Further description of listed complaints.

1. I worked with AZ Solar Living (the Contractor) on a layout that would mitigate shade as much as possible and after several configurations, we agreed on the attached layout. This layout also properly followed the necessary Fire Dept. setback rules for solar PV installs.

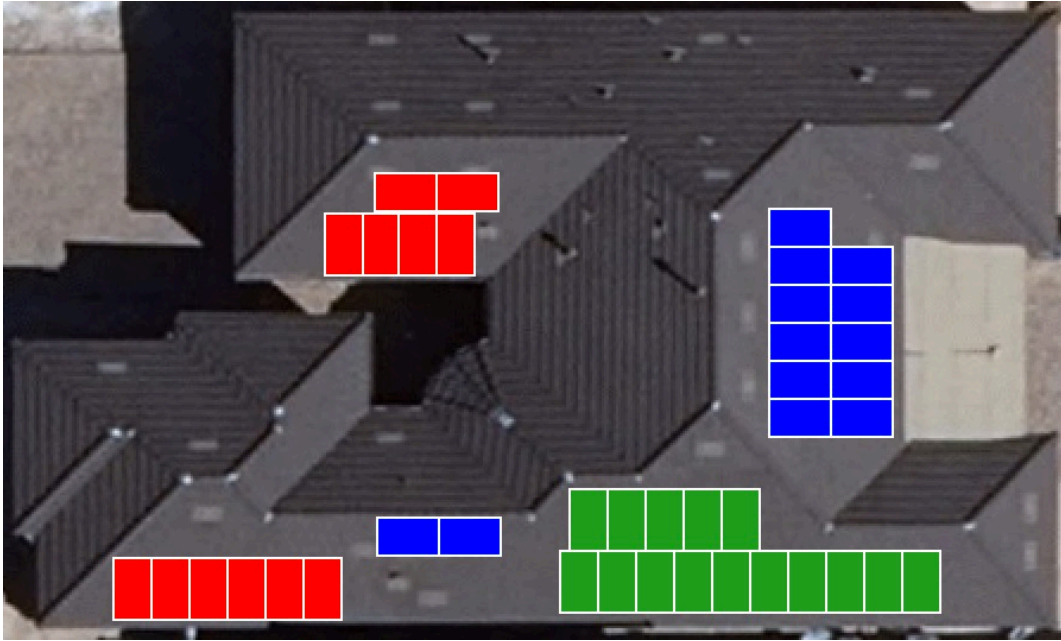
The permit was submitted to the city with a slight modification but followed generally the same layout and met the required code.

Once the install of the roof mounts and racking was actually completed by the Contractor, they were placed in a way that the layout of the panels would have not followed the agreed on design, the permit, or the fire code setback.

I advised the Contractor that I did not feel the mounts and racking were installed correctly and that they did not meet the required fire setback code and was told "It will be fine".

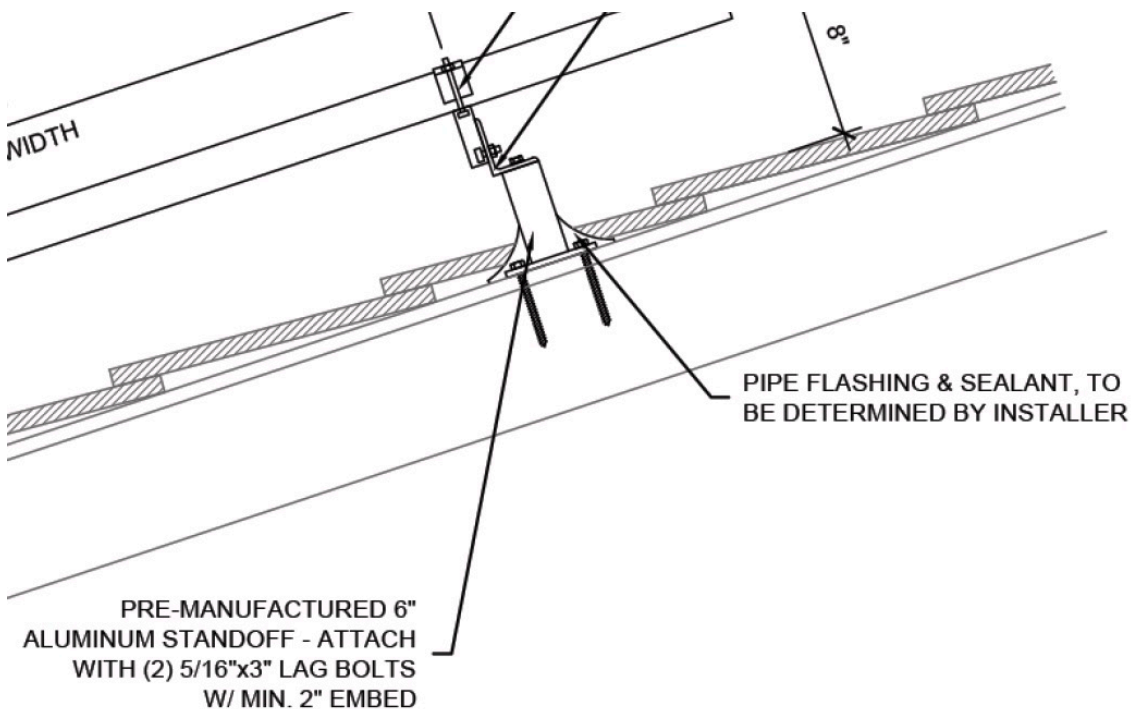
2. The Contractor used zinc coated hanger bolts for the installation of the solar racking mounts. The permit specified pre-manufactured 6" aluminum standoffs attached with (2) lag bolts. I specifically asked the Contractor to send me a copy of the permit prior to submitting it to the city to make sure we were "on the same page" as to how and what was being installed and fully expected the mounts to match the permit submitted and approved. I brought up the issue with the Contractor upon seeing the hanger bolts and was told the permit showed just a "generic" model and that it did not have to match exactly. I placed a call to the City of Peoria and was advised that information is not correct and that the mounts do in fact have to visually match the permit and be rated for the wind and load bearing specified on the permit.

This is what the permit specified:

This is what was installed by the Contractor:

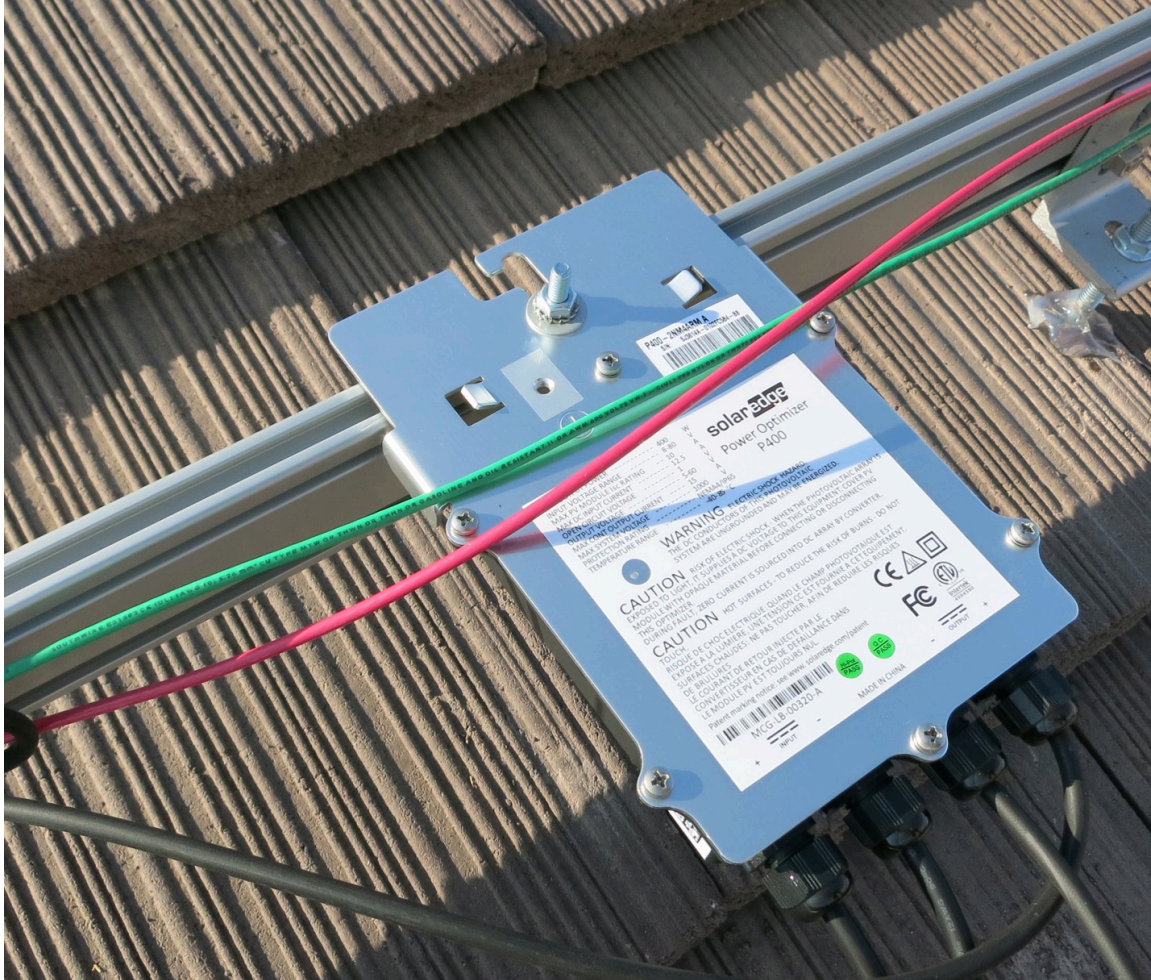
3. Contractor installed the improper roof mounts (hanger bolts) by drilling through the flat roof tile and into the roof rafters and applied silicon as a sealant on top of the tile and on top of the underlayment. I contacted several roofing companies to confirm if this is an acceptable roofing method and all of them said it was incorrect, not to code and not to acceptable standards. I was advised by the roofing companies that the silicon sealant would last at most a couple of years under the Arizona sun and the penetrations would most definitely leak.

In addition, upon inspecting the work myself, I found several penetrations that the Contractor did end up not using (did not install a hanger bolt at that location) which some were filled with silicon sealant while others were not and were left free to leak.

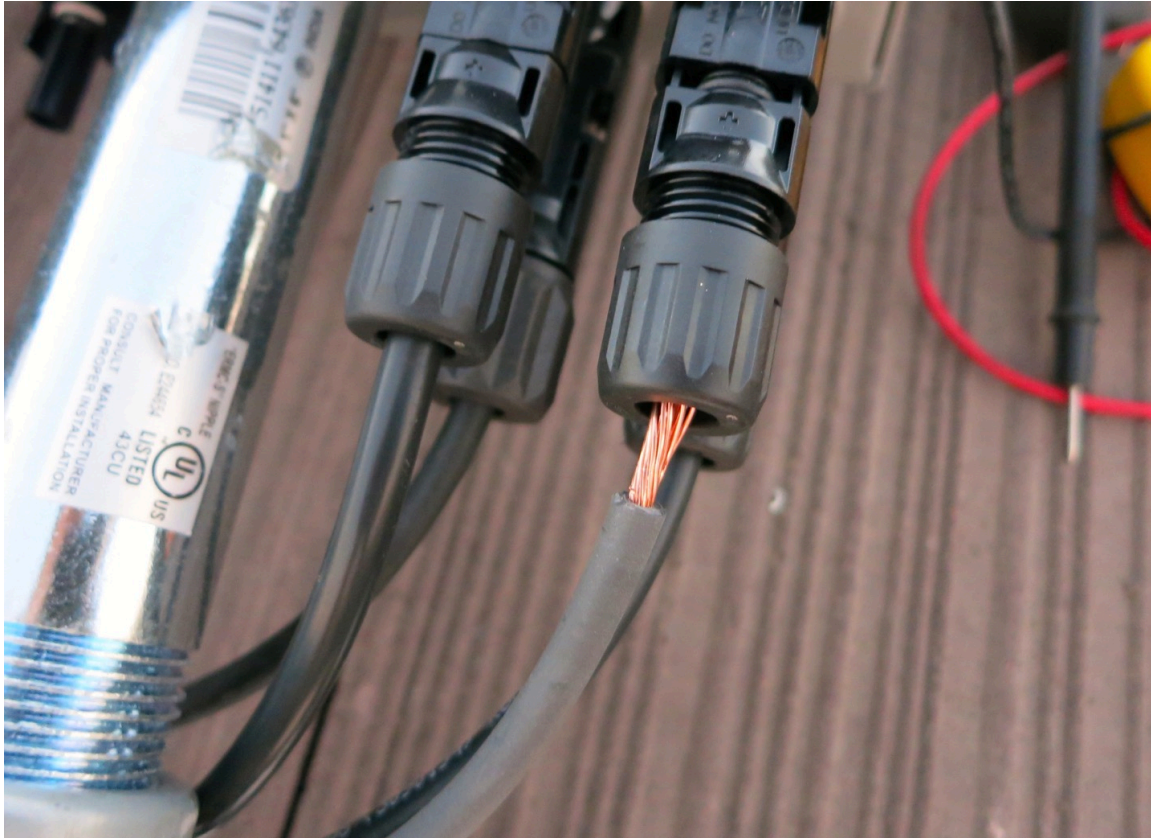
6. I advised the contractor that the plastic liquid tight conduit is not acceptable, both per the permit and aesthetically. The contractor replaced the plastic conduit with EMT, however the incorrect size was again used and did not match the specifications of the permit. This was one of the main points of why the project failed city inspection.
